Comparison of Alternatives

Per your request at the June 11 RPG meeting regarding ideas for alternative projects to the Gillespie-Newton TL, please see LCRA TSC's response.

At the June 11, 2010 ERCOT Regional Planning Group (RPG) meeting you solicited ideas from the RPG participants associated with the June 01 request from Commissioner Smitherman regarding the CREZ Transmission Plan (CTP) Gillespie – Newton 345 kV transmission line project.

Scenario 17 (Alt 1)

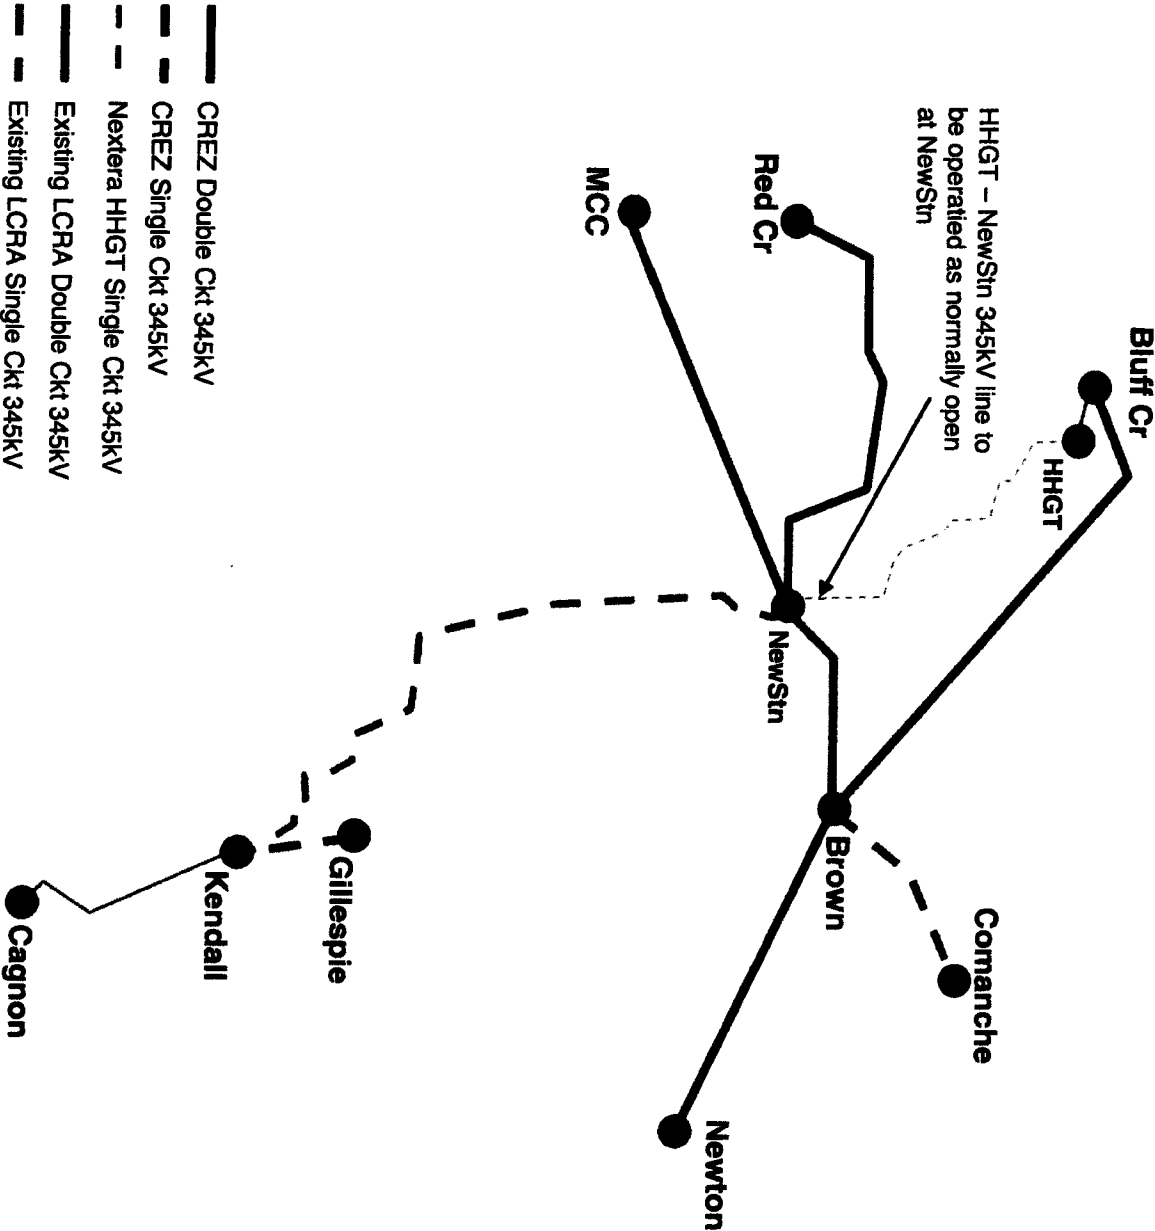
Comparing the approved ERCOT Scenario 2 CTP and the change we discussed (that I will call in this note "Scenario 17"), it appears that in the Scenario 17 configuration, the line from the New 345 kV Station to Kendall with a rating of slightly over 1200 MW becomes the immediate limit. This is not an ideal planning solution -putting something in place that is a bottleneck from day one! If you would recall, in its CTO study and in its 2006 study, ERCOT stated that a path that extended from the west to the southeast was key to the success of CREZ.

Also, not to my surprise, the configuration in Scenario 17 tends to push less power south towards Kendall and more along the Brown-Killeen-Salado path and creates an overload of the Killeen-Salado 345 kV TL as well. Also, not an ideal planning solution for similar reason as before.

opinion. It is clear to me that Scenario 17 does not offer that expandability for larger build out of wind generation without significant new TL construction.

I would not support placing at risk progress on the approved CTP for studying the merits of Scenario 17.
